Public Comments Received

[EXTERNAL] EPA comments on Oklahoma's Proposed Regional Haze SIP for the 2nd Planning Period

RE: Proposed Regional Haze State Implementation Plan for the Second Planning Period

EPA Comments on Oklahoma RH SIP Public Comment Draft
July 1, 2022

Figure 1. Hugo Unit 1 Historical Emissions

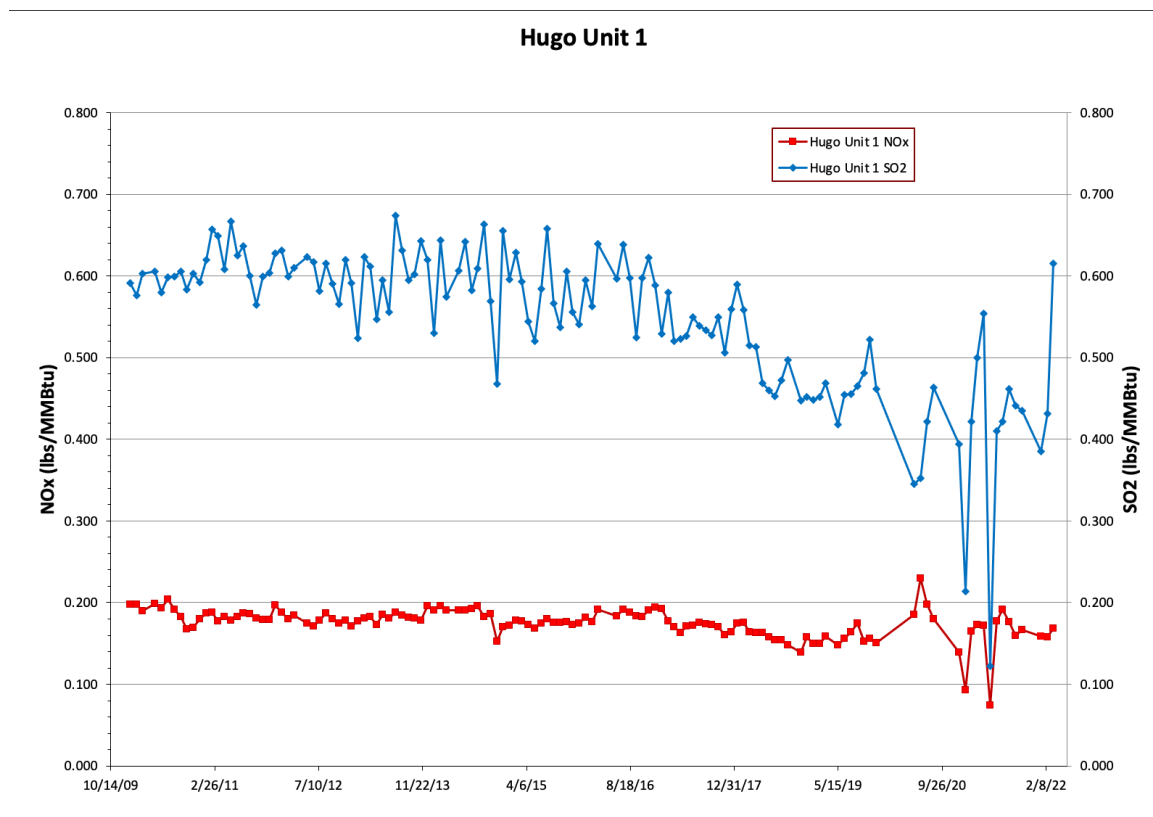
The SO₂ and NO_x emissions for Hugo Unit 1 are presented below:⁵⁹

Figure 2. GREC Unit 2 Historical Emissions

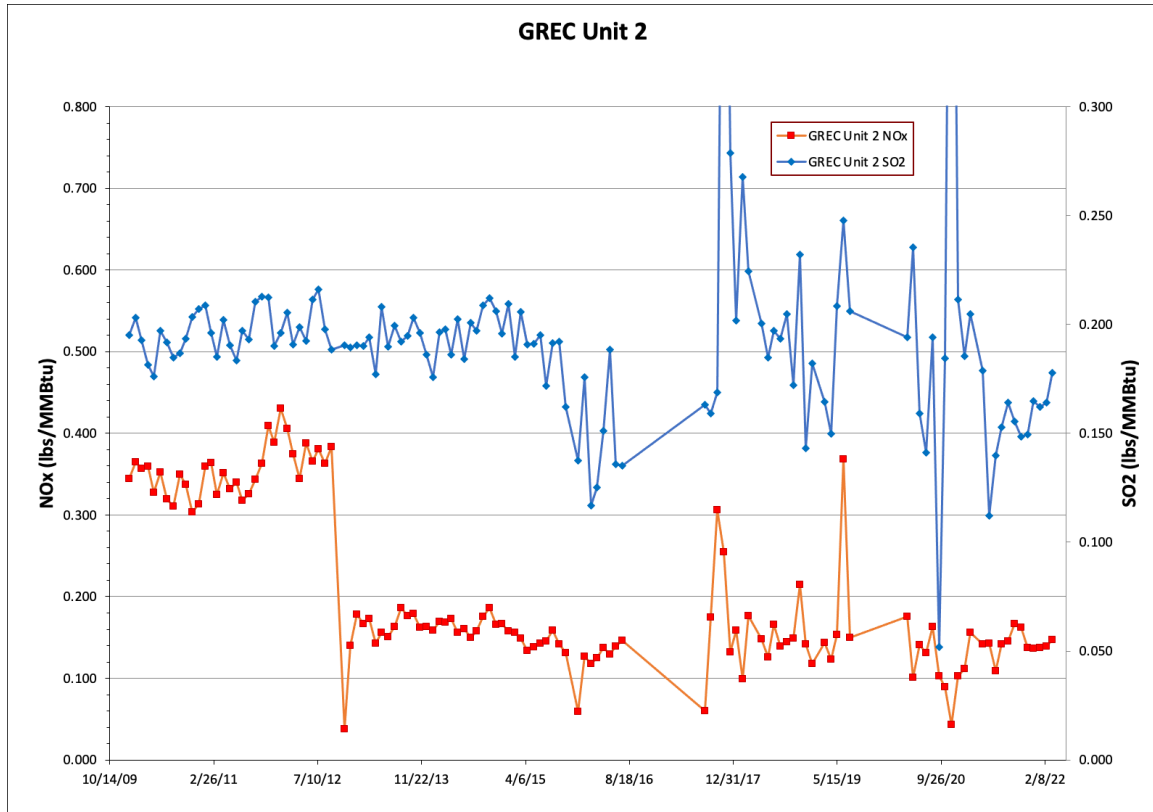
As can be seen from the above graph, starting in September 2012, the NO_x emissions for Unit 2 significantly improved. Also, beginning in late 2015, the SO₂ emissions for Unit 2 became erratic. There is no discussion for this in GREC’s four-factor analysis and ODEQ must require it, as it impacts that analysis.
